# Access Compliance Report

## Public Rights-of-Way

### (Curb Ramps)

Intersection ID: 28011	Main Street: CHANCELOT_LN	Cross Street: LEGACY_CR	Location: NW
ADA ID: 7795E7D27556	Ramp Type: Perp	Initial Pass/Fail: Fail	Overall Compliance: No
Severity Score: 47.5			
Codes/Mitigation Info/Possible Solution		Field Measurements/Component Compliance

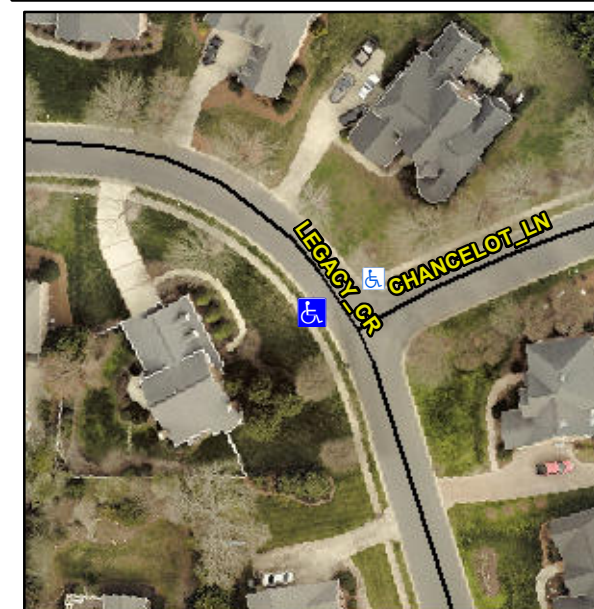
**Not Found, R304.5.1, R304.2.2**

Compliance	Description	Data	Compliance	Description	Data
N/A	Ramp Length (in)	48.0	No	Ramp Slope (%)	8.5
No	Ramp Width (in)	30.5	Yes	Ramp XSlope (%)	0.3
N/A	Flare Type LT	N/A	N/A	Flare Type RT	N/A
N/A	Flare Slope LT (%)	N/A	N/A	Flare Slope RT (%)	N/A
N/A	Flare Traversable LT?	N/A	N/A	Flare Traversable RT?	N/A
N/A	Landing Length (in)	N/A	N/A	DWS Provided?	N/A
N/A	Landing Width (in)	N/A	N/A	DWS Contrast?	N/A
N/A	Landing Slope (%)	N/A	N/A	DWS Length (in)	N/A
N/A	Landing X Slope (%)	N/A	N/A	DWS Full Width?	N/A
N/A	Landing Curb? (Y/N)	N/A	N/A	DWS Offset (in)	N/A
N/A	Shared Landing?	N/A			
N/A	Gutter Ponding?	N/A	N/A	Gutter Slope (%)	N/A
N/A	Gutter Lip Ht (in)	N/A	N/A	Gutter X Slope (%)	N/A
N/A	Painted X Walk1?	No	N/A	Painted X Walk2?	N/A
	X Walk 1 Direction	To NE		X Walk 2 Direction	N/A
N/A	X Walk 1 Width (in)	N/A	N/A	X Walk 2 Width (in)	N/A
	X Walk 1 Slope (%)	1.0		X Walk 2 Slope (%)	N/A
	X Walk 1 X Slope (%)	0.6		X Walk 2 X Slope (%)	N/A

**Remove & Replace Entire Ramp.**
